Project	IEEE 802.16 Broadband Wireless Access Working Group < <a href="http://ieee802.org/16">http://ieee802.org/16</a> >	
Title	Figure 20L Correction and Clarification	
Date Submitted	2005-07-10	
Source(s)	Yair Bourlas, Lei Wang, Cygnus Communications Inc.	Voice: 760-448-4168 Fax: 760-448-1989 <a href="mailto:lwang@cygnuscom.com">lwang@cygnuscom.com</a> <a href="mailto:ybourlas@cygnuscom.com">ybourlas@cygnuscom.com</a>
Re:	This contribution provides a correct drawing of Figure 20L for 802.16e.	
Abstract	[Description of document contents.]	
Purpose	The purpose of this contribution is to provide a correct drawing of Figure 20L.	
Notice	This document has been prepared to assist IEEE 802.16. It is offered as a basis for discussion and is not binding on the contributing individual(s) or organization(s). The material in this document is subject to change in form and content after further study. The contributor(s) reserve (s) the right to add, amend or withdraw material contained herein.

## Figure 20L Drawing Correction

**Figure 20L—Extended subheader format**

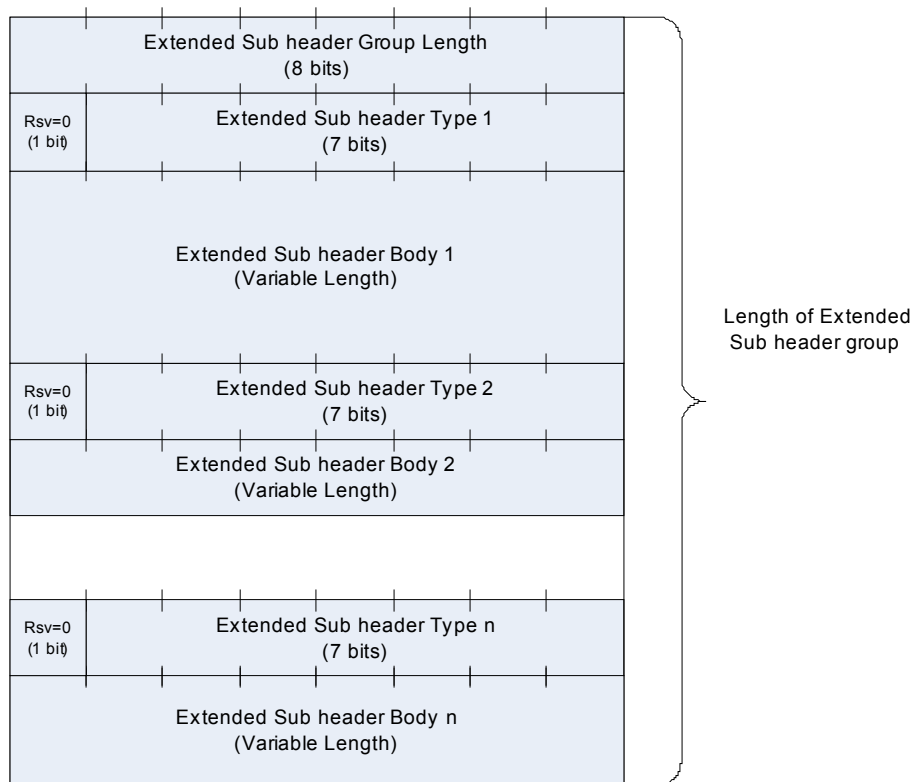
Figure 20L in 16e/D9 needs to be corrected. Clarification text is also added.

In 802.16e/D9, page 32, line 42, replace the Figure 20L by the figure and the paragraph below:

The extended subheader group starts with an 8-bit length field that is followed by one or multiple extended subheaders. The length field specifies the total length in bytes of the subheader group, including all the subheaders and including this length byte. Each subheader consists of a reserved bit, a 7-bit extended subheader type field, and a variable size extended subheader body. The size of each extended subheader is determined by the extended subheader type as specified in Table 13b.
